Hot briquetted iron project, Port Hedland

BHP Direct Reduced Iron Pty Ltd

**Report and recommendations
of the Environmental Protection Authority**

**Environmental Protection Authority
Perth, Western Australia
Bulletin 784
June 1995**

Figure 1. Site and infrastructure relationship, and noise buffer

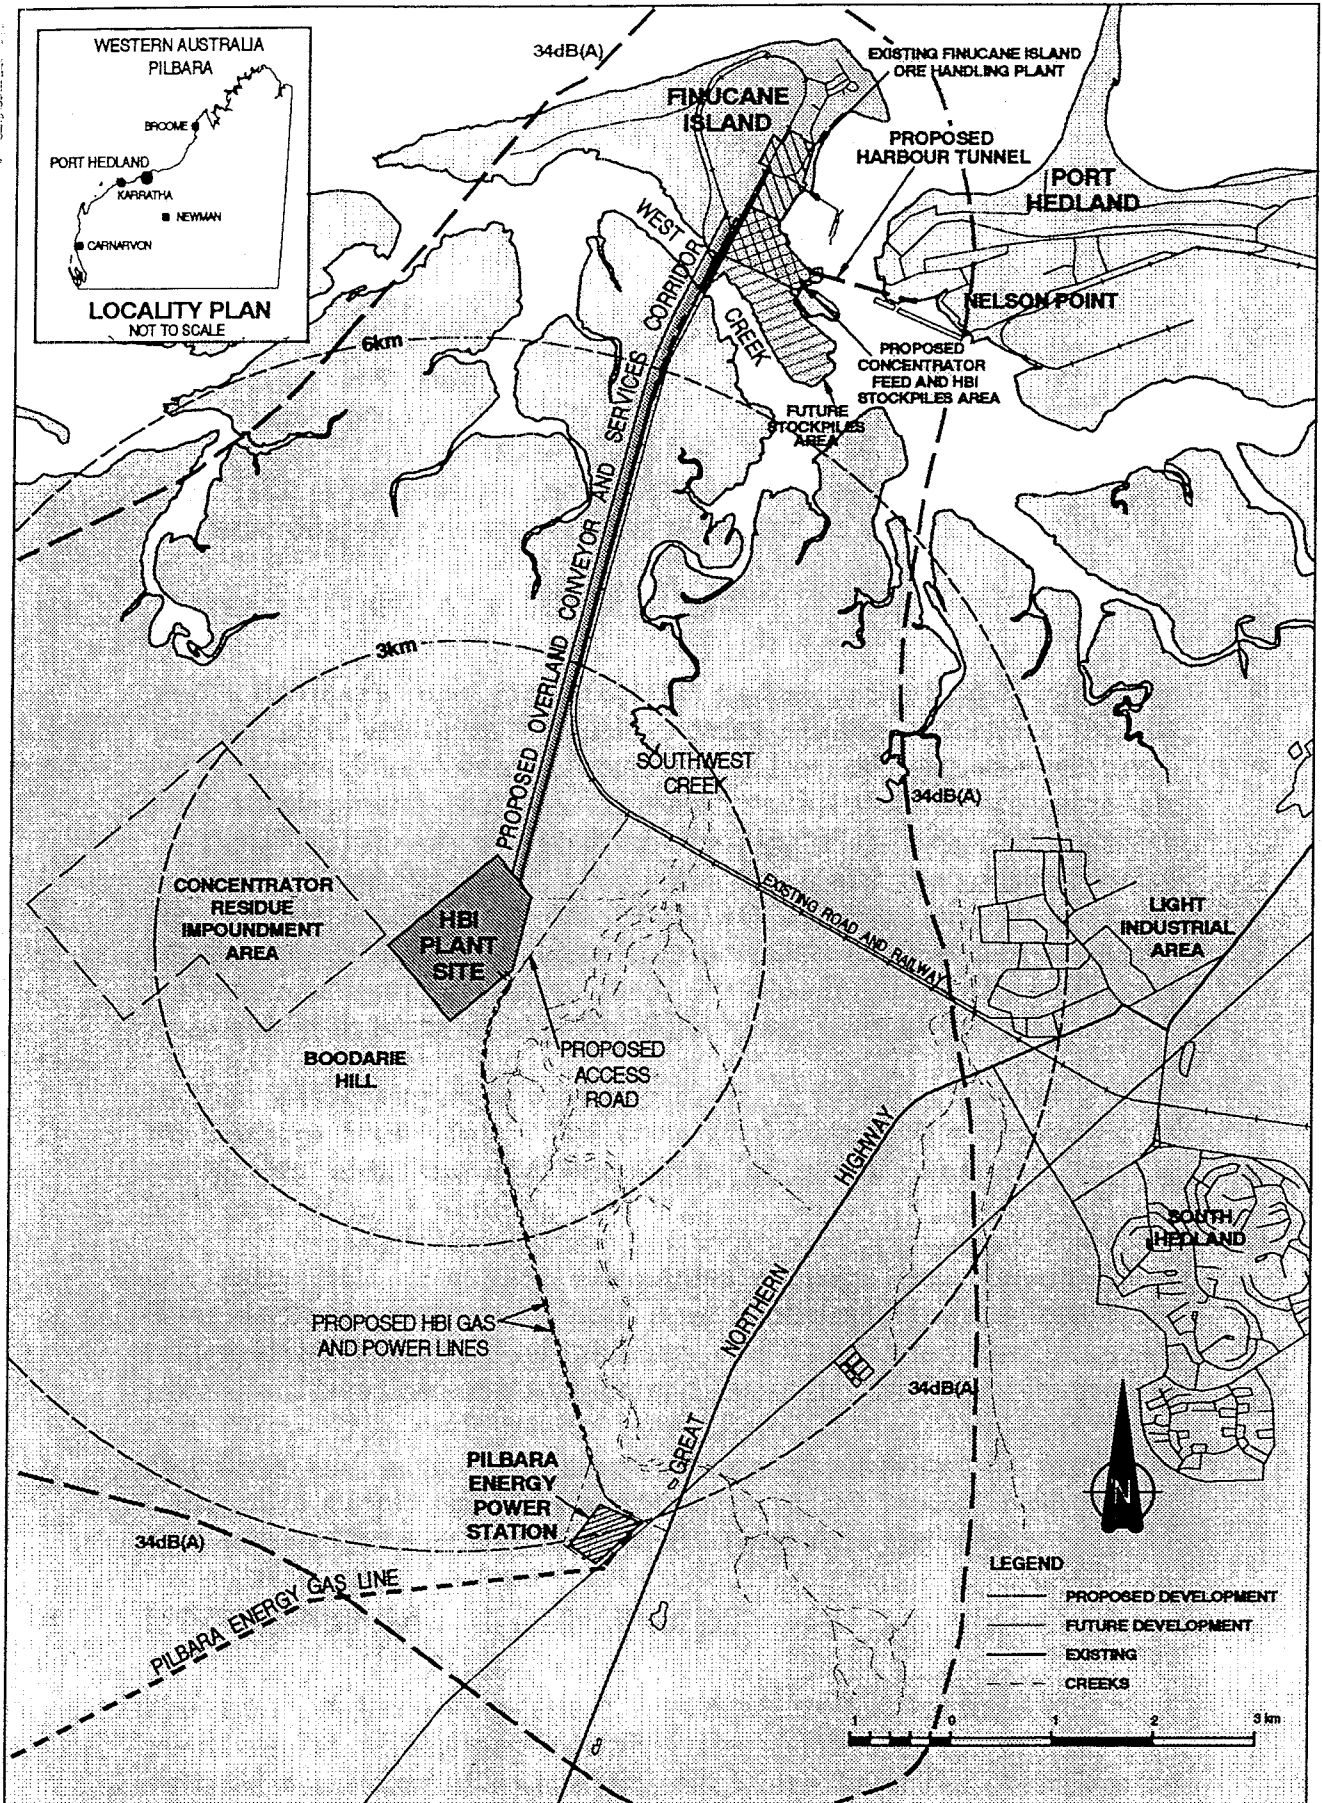
A noise buffer zone was also established for a worst case noise emission scenario. Figure 1 shows the 34 dB(A) buffer zone boundary. The proponent has indicated that it will apply for a buffer zone to exclude future residential development within this area under the State Agreement Act.

Long term security for the buffer zone around the plant site is essential to maintain the environmental acceptability of the proposal, especially for noise (and dust) emissions. The proponent has identified a distance of 5 km as being necessary for noise compliance (CER), and has sought to have this addressed through the State Agreement Act being developed for the proposal. Should the State Agreement Act not secure the buffer zone, then the EPA considers that an alternative mechanism be implemented and the EPA advised of this. The EPA has recommended accordingly (Recommendation 4).

Figure 8. Storm surge/flood levels and location of mangrove clearing

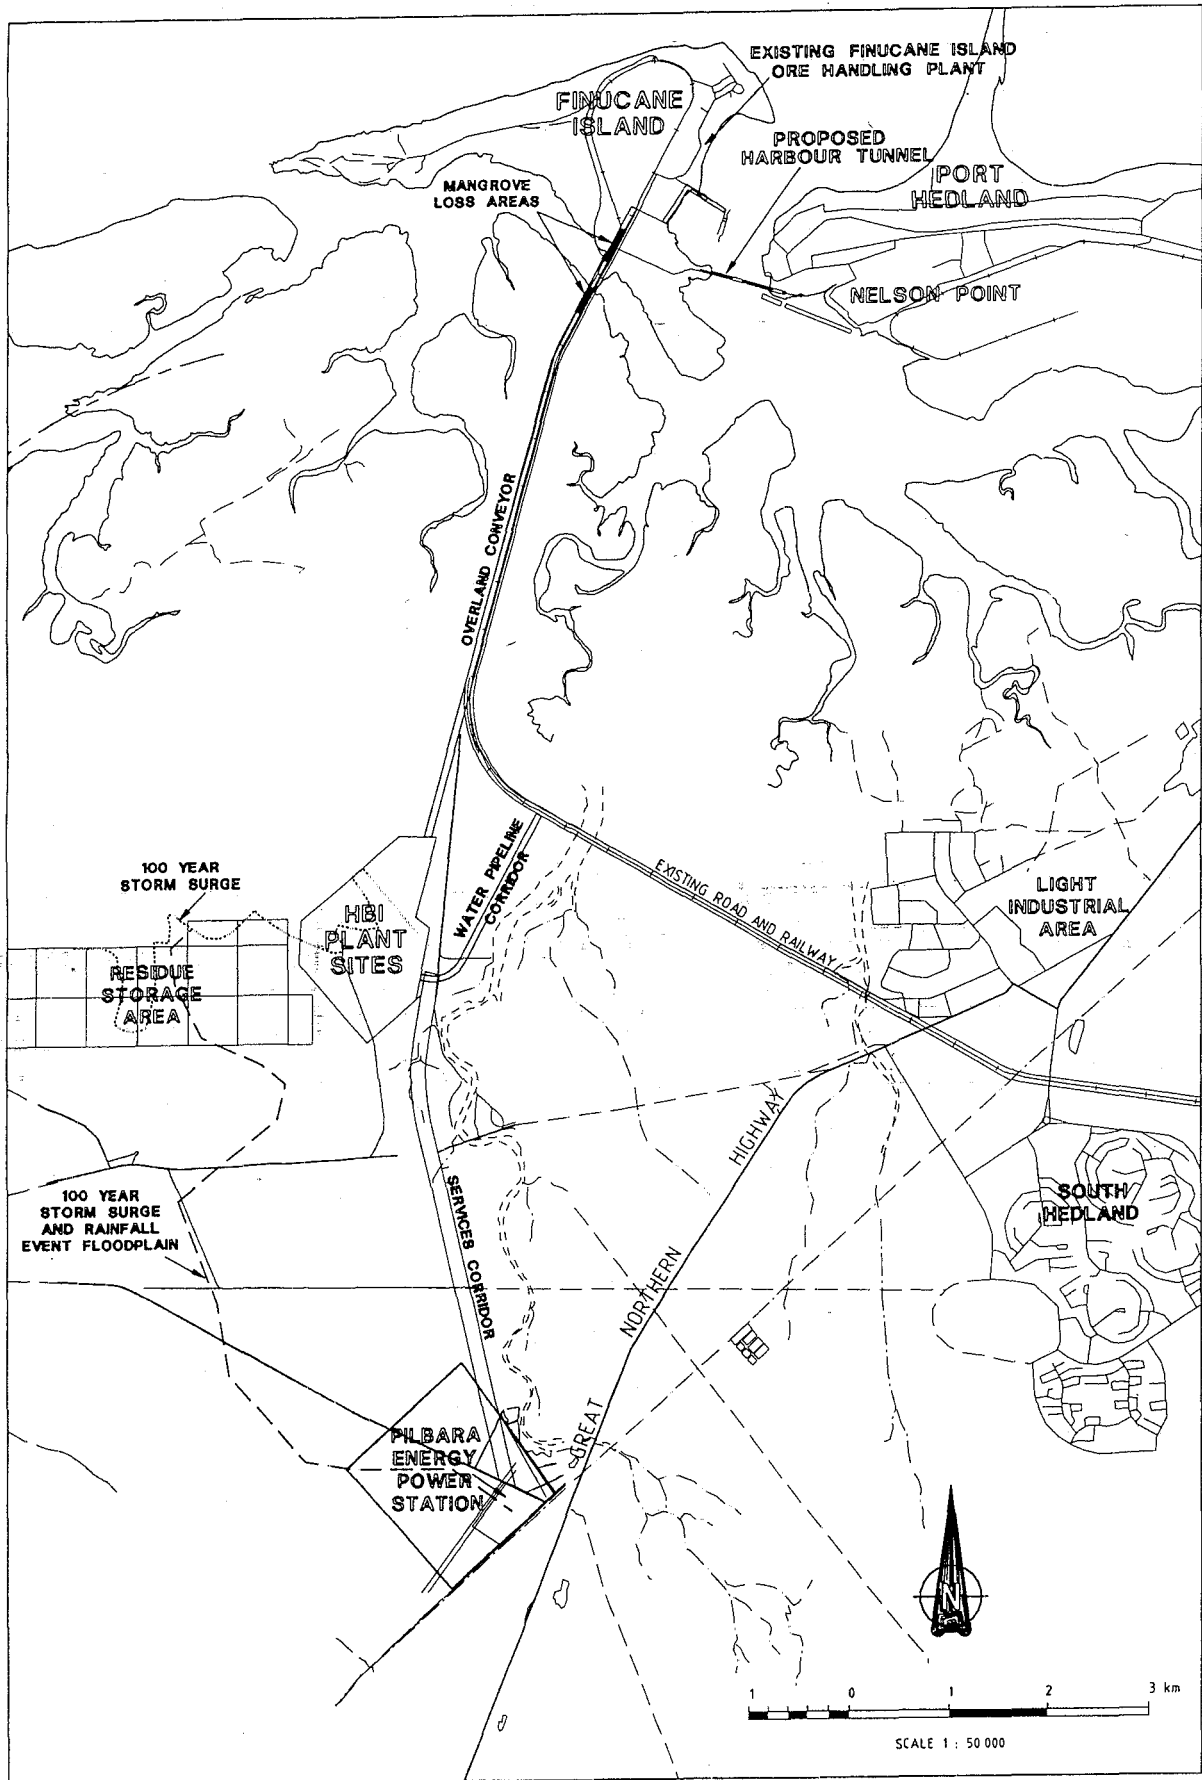
Even though the Department of Transport advised that it has not identified any problems with the proposal being located in the 1:100 year storm surge inundation area, based on the 1993 storm surge analysis (Smith & Hubbert, 1993), it provided the following comment:

"The report by Davies concentrates on the effect the installation will have on the surrounding area. It does not consider the effect of flooding on the plant itself, and indeed this may not be a problem, but we have not been supplied with any levels of the finished project. The effects of flooding on the development was not addressed in the risk analysis in the CER. However given that there is a 69% probability that the 1:100 year return period storm surge event will be exceeded every 100 years, it would be prudent to ask what the effect water levels in excess of the 100 year event would have on the proposal, to confirm that this is an appropriate design level".

The submissions expressed concern with the location of the HBI plant (and the forthcoming Boodarie Heavy Industrial Site) on the current flood plain, which would change flooding patterns and most likely lead to the flooding of South Hedland and Wedgefield Light Industrial Site. Some submissions raised concern about the backflooding effects of the existing Goldsworthy railway (Finucane Island road/railway crossings) to South Hedland, resulting from "poor drainage design involving inadequate culverts under the railway to Finucane Island and a major creek diversion", and requested that a drainage study should be carried out on these effects. A submission from the Local Environment Affinity Force (LEAF) expressed a concern about inadequate storm water evacuation at South Creek, Middle Creek and South West Creek, and that the addition of the Boodarie rail depot, the spur railway lines and the road on the eastern side with their extra height would increase the possibility of backflooding into South Hedland during the next storm surge.

A submission from the Town of Port Hedland (Chapple Research, 1995) raised a number of issues relating to the consultant's hydrologic analysis (Davies & Associates, Nov 1994). The issues include lack of consideration on the backflooding of South Hedland and Wedgefield Light Industrial area resulting from the HBI proposal alone and from the combined effects of the HBI project, the transport corridor, the power plant and the proposed Heavy Industrial Site; the assumption on sheet flooding flow in contrast with the drainage study done by the same consultant for the Boodarie Heavy Industrial Site; no recognition of the railway embankment at South West Creek being inundated during the 50 and 100 year storm surge events; and no consideration of potential increase in rainfall resulting from the greenhouse effect.

In response to the comment made by the Department of Transport, the proponent indicated (Appendix 4) that since it was identified in the Davies (Nov 1994) report that the 1:100 year flood level from South West Creek is higher than the storm surge level, the critical facilities of the plant will be designed to be protected from the effects of a 1:100 year event during the detailed design. The Bureau of Meteorology is currently carrying out studies of the consequences of the 1:100 and 1:50 storm surges as they affect Finucane Island and the Boodarie site, which are due for completion by end of June 1995.

- The results of the Davies study (Nov 1994) indicate that backwater effects due to the positioning of the HBI plant site on the edge of the South West Creek flood plain do not extend beyond approximately 2km upstream from the plant site. Hence no increased risk of flooding to South Hedland as a result of the proposed HBI plant site location is expected. Additional hydraulic analysis is being carried out by Jim Davies & Associates and a draft report is due for completion by end of May 1995.

- The proponent is not aware of any studies undertaken to assess the possibilities of flooding in South Hedland as a result of existing drainage arrangements relating to South Creek and South West Creek culverts, the railway embankment, the training wall/culvert along the railway overflowing from South West Creek. However the construction of the overland conveyor and service corridor as designed for the HBI plant are likely to improve area drainage. The HBI project will maintain the current flow pattern during major flood events (ie. the South West Creek flow is diverted by the Goldsworthy Railway embankment via a north-westward flowing drain). Where the conveyor and services cross the diversion drain, the conveyor will be elevated on trestles and a floodway will be constructed, with suitable scour protection, to pass these flood waters.

The EPA has taken into consideration advice from the Water Authority and the Department of Transport that the location of the proposal on a storm surge and flood plain area is acceptable and the resultant risks can be managed with appropriate engineering design. The EPA notes the Water Authority's recommendation on the minimum foundation level for the HBI plant site and the engineering design for the earth training wall, and believes that the proponent should take into consideration the Water Authority's recommendation.

Figure 9. Schematic layout of concentrator residue storage impoundment

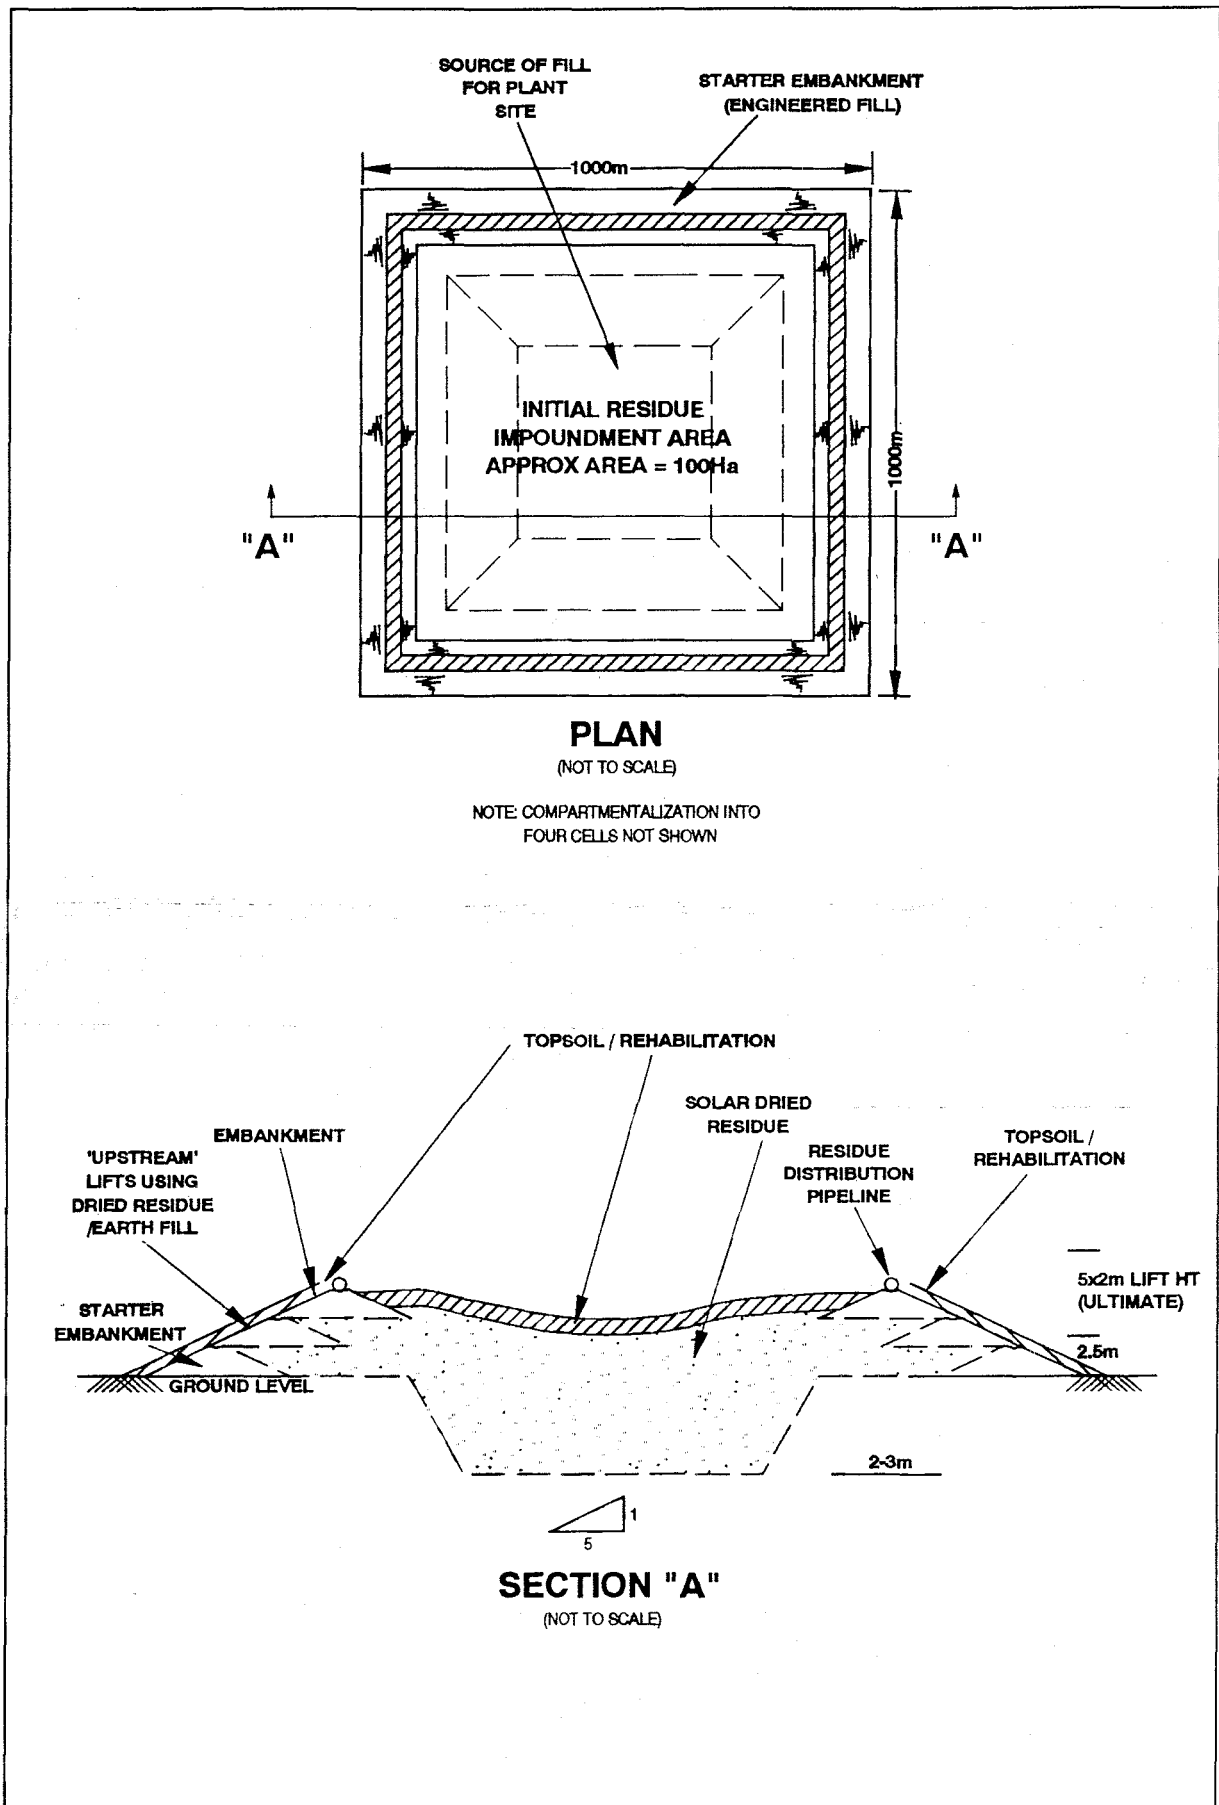
"The Geological Survey Division (DOME) fully endorses relocating the impoundment above the 1:100 year flood line and proposed the construction of a protecting embankment (levee or dyke) within the storm surge line.

It may be worth noting at this stage that a 1:100 year flood line or contour does not necessarily represent the point or level at which total failure will take place and the result may only be, for example, that a structure fails to perform for some time. The design

may assume that flood or storm surge water could come into contact with the structure, but the effects of this can be minimised by incorporating further designs into the structure such as the proposed embankment, embankment protection or the excavation of diversion channels.

In other words, being within a 1:100 year limit does not necessarily mean catastrophic failure will result if those predicted, usually statistically derived, levels are reached. However it is interesting to note that other structures, namely the HBI plant and concentrator will be located on a raised pad constructed using borrow material from the base of the proposed residue impoundment. Therefore, perhaps some future thought will be given to including simple toe protection to the residue impoundment starter embankment to minimise the effects of potential erosion from floodwaters (or cyclonic rain event)".

"As advised, DRD has agreed in principle with BHP that land to the north of latitude 7744000N (on the map provided) can be used for the HBI plant and associated residue storage ponds. DRD has said that land to the south of the 1:100 storm surge line is prime industrial quality and should not generally be used for waste storage purposes."; and

- the residue will be contained behind engineered embankments, to cater for flood protection. The starter embankment will initially be 1 to 3 metre high. Topsoil stripped from the internal areas of the impoundment will be used for rehabilitation and for the HBI plant site fill. It is proposed to place the stripped material around the outside of the starter embankment to act as a buffer and erosion protection zone (about 20 m wide), which in time will be revegetated; and
- the residue impoundment will be designed and managed so that failure and subsequent discharge of residue will not occur under the design events. DOME and WAWA will be consulted to ensure that engineering design and statutory requirements are met (Commitment 32 of Appendix 6).
